Corrective Action 1525
Carondelet Division
Corrective Action Type NCR
Date 1-9-06 Revised 1-20-06
CA Originator C. Ruud
Applies to: A-2 Coil

A-2 Coil has excess stock in 2 areas.

NOTES: Repair of A-2 Coil Casting

Attachment to Supplemental router for A-2
Differences between A-1 & A-2

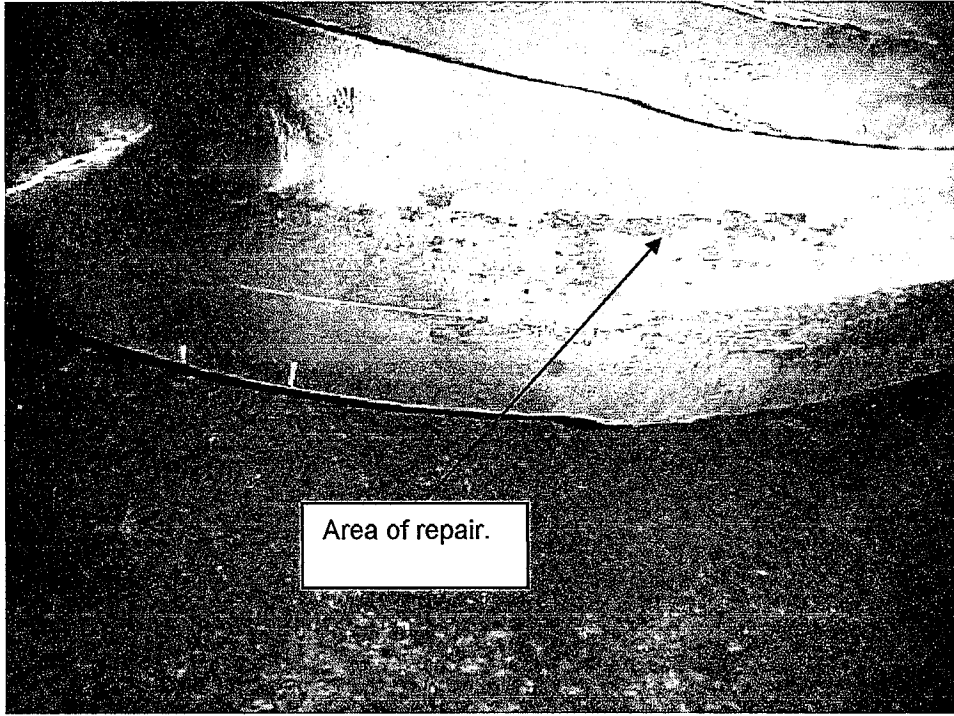
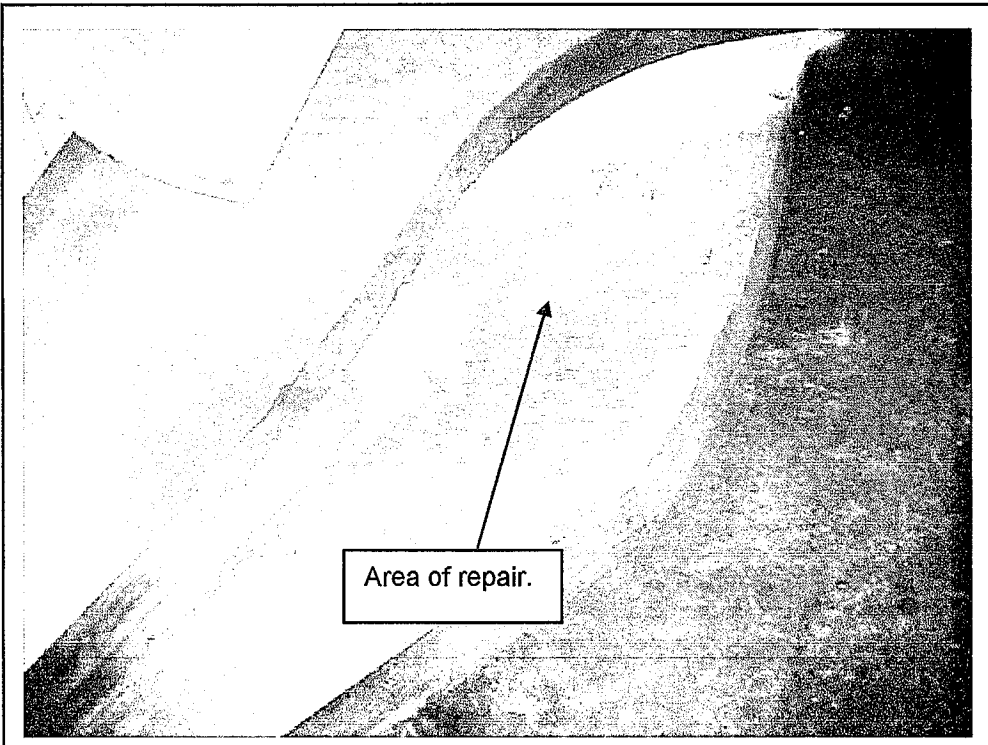
Excess material is feed pads for risers. They were not removed during arc air operation. There is no work instruction for the A coil.

Area of repair.

Area of repair.

Remove excess material at CAF. Verify repairs with VT, PT and mag perm inspections. See attached supplemental MTS and pictures showing the repaired areas.

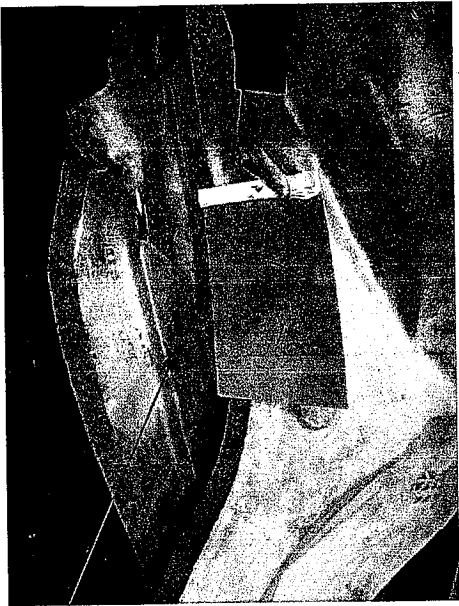
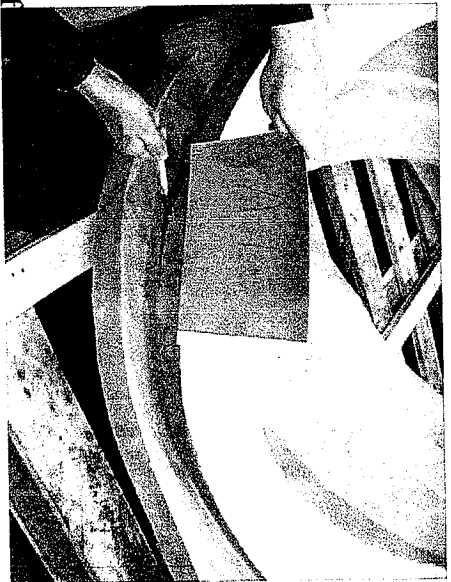
Detail on A-1 was ground off

Detail on A-2 needs to be removed

Attachment to Supplemental router for A-1
 Differences between A-1 & A-2

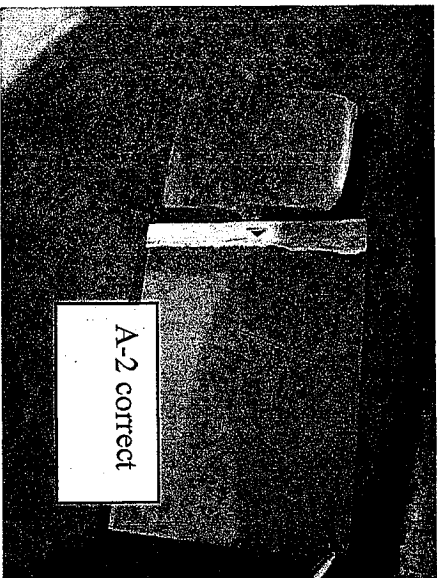
This detail is acceptable,
 leave as is.

This is excess material, remove.

A-1
 See engineering for
 the material to be
 removed from this
 boss.

Detail D on A-1 - MTM to machine flat
